Our Ref: BE240537-RFI-01
 Enquiries to: Dale McInnes

**Re: Lot 38, 100 Delathin Rd Algester QLD 4115
 Information Request Response (Ref: A006988151)**

We refer to the Council of the Brisbane City Council Information Response dated 24th April 2026 regarding the above project. Please find below responses addressing items 1 to 5 of the issues raised. Items 5 and 6 are being addressed by other consultants associated to the project.

DRAWING TITLE:
CONCEPT FINISHED GRADING AND DRAINAGE LAYOUT PLAN

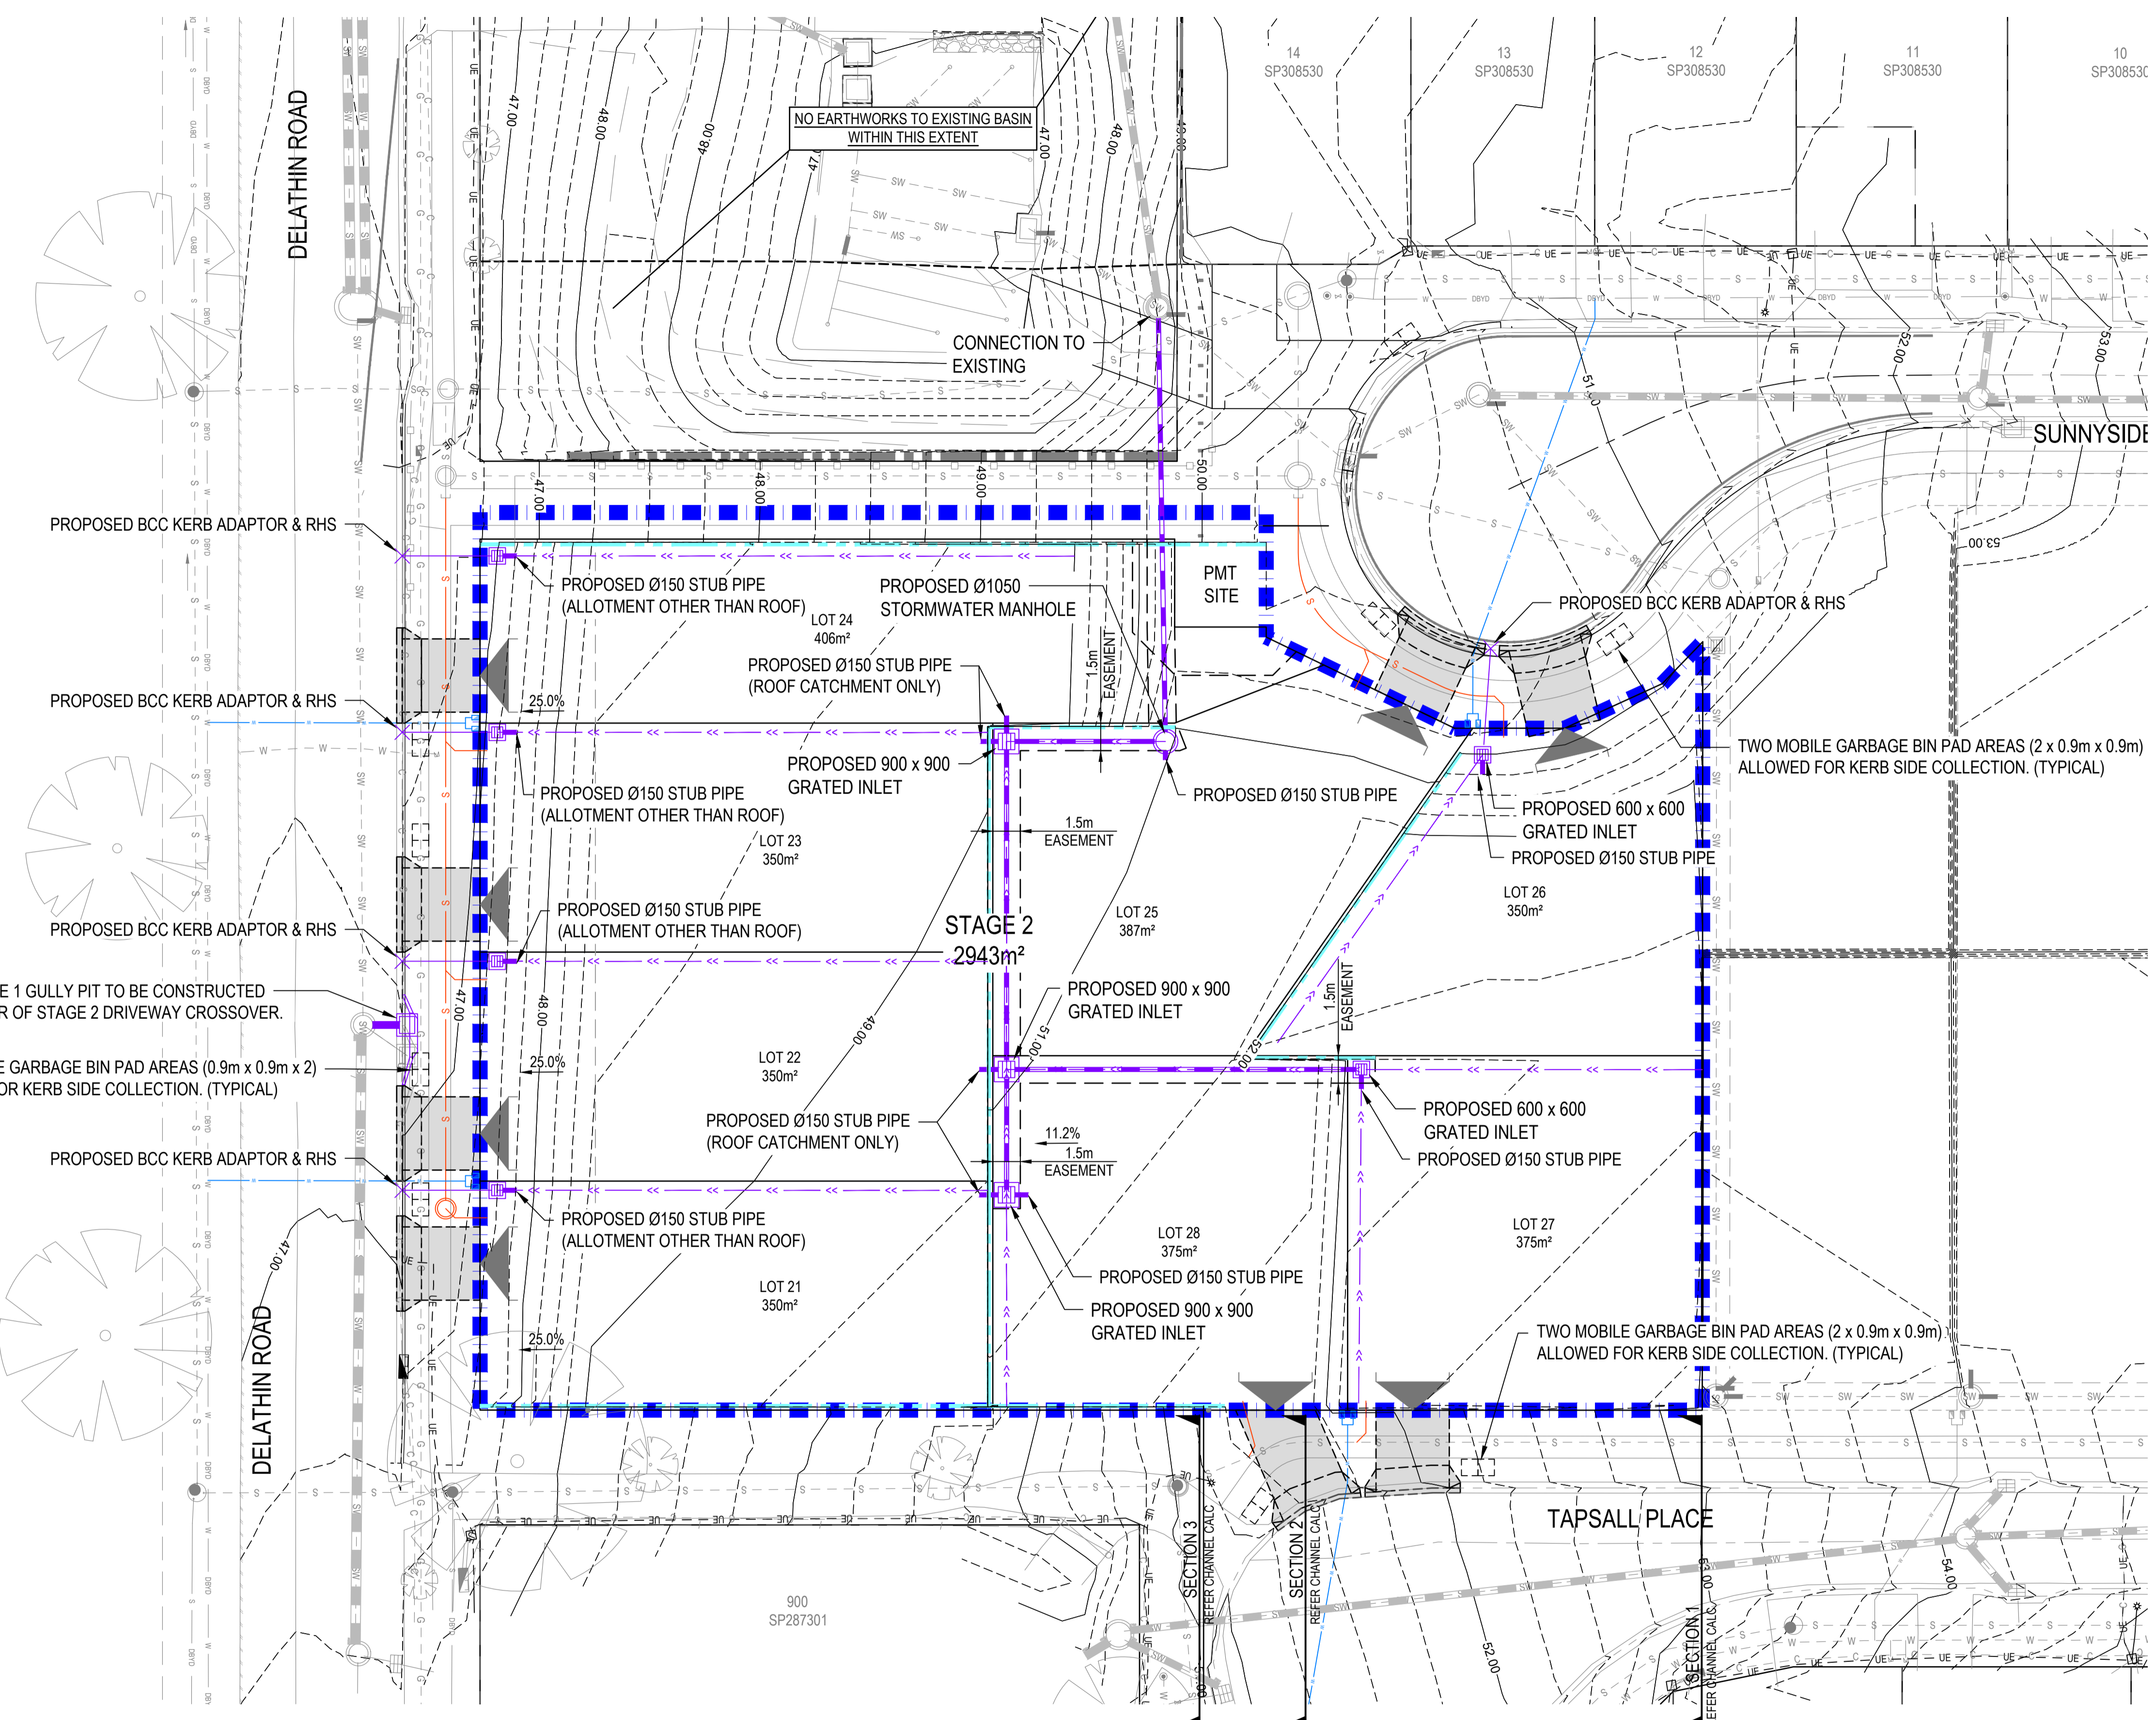
2	Provide amended engineering plans that demonstrate compliant standard residential driveways for Lots 24 and 25, while also allowing sufficient frontage space for the presentation of 2 mobile garbage bins (MGBs) for curbside refuse collection per lot.	<p>A 4.0m wide Standard concrete residential driveway crossovers are proposed for Lots 24 and 25 and have been shown on the associated civil plans including areas to support 2 MGB per lot.</p> <p>Refer 'Concept Finished Grading and Drainage Layout Plan C3110 [REV B]' for further details.</p>
3	Provide amended plans that demonstrate compliant standard residential driveways and sufficient area for bin presentation for 2 MGBs for Lot 28. Noting the Transport, access, parking and servicing code restricts driveway encroachment onto neighboring frontage.	<p>The driveway location for Lots 28 has been aligned perpendicular/central to the cul-de-sac bulb of Tapsall Place and is positioned accordingly and to normal practice.</p> <p>Due alignment of the kerb and channel of the cul-de-sac changing direction and not remaining parallel to the property boundary, the encroachment needs to be considered with respect to the side boundary to the center of the cul-de-sac as shown below in red.</p>  <p>A 4.0m wide Standard concrete residential driveway crossovers is proposed for Lots 28 and 27 and have been shown on the associated civil plans including areas to support 2 MGB per lot.</p> <p>Refer 'Concept Finished Grading and Drainage Layout Plan C3110 [REV B]' for further details.</p>

4	Confirm on amended plans the future driveway locations for lots 27 and 28 do not conflict with the existing pedestrian access from Tapsall Place through to Delathin Road.	<p>Driveway crossovers for Lot 27 and 28 have been shown on the associated civil plans which show no conflict to the existing pedestrian access from Tapsall Place through to Delathin Road and including areas to support 2 MGB per lot.</p> <p>Refer 'Concept Finished Grading and Drainage Layout Plan C3110 [REV B]' for further details.</p>
Overland Flow		
5	Provide confirmation from an RPEQ engineer that overland flow from Tapsall Street will not adversely impact these lots.	The approved CSMP indicates during a 1% AEP storm event and assuming the in-ground

<p>stormwater is 100% blocked, a conservative 0.47m³/s will flow down Tapsall Place is expected.</p> <p>To prevent overland flow entering Lots 27 and 28, the verge works from the back of the existing kerb and channel to the property boundary adjacent to cul-de-sac and adjacent to lots 27 and 28 have been graded to fall at 2% grade towards Tapsall Place.</p> <p>Three (3) key sections have been taken at across Tapsall Street and a 'Channel Capacity Calculation' performed using the conservative 1% AEP storm event flows.</p> <p>Section 1 is positioned at the side boundary of Lots 11 and 27 and indicate the depth of flow will be approx. 92mm and is contained within the Tapsall Street carriageway (assuming in-ground drainage is blocked).</p> <p>Section 2 is positioned slightly down from the side boundary of Lots 28 and 27 and indicate the depth of flow will be approx. 106mm and is contained within the Tapsall Street carriageway (assuming in-ground drainage is blocked).</p> <p>Section 3 is positioned behind the backstone of the sag gully pit and indicate the depth of flow will be approx. 98mm flowing over the verge towards the existing basin (assuming in-ground drainage is blocked).</p> <p>Furthermore, the existing gully pit located at the sag point in Tapsall Street has a surface level of RL51.03 at the backstone and Lot 28 has a frontage surface level of approximately RL 51.5 which exceeds will have 372mm freeboard $(51.50 - (51.03 + 0.098) = 0.372\text{m})$.</p> <p>Refer 'Concept Finished Grading and Drainage Layout Plan C3110 [REV B]' for section locations and refer to Channel Capacity Calculations attached.</p>
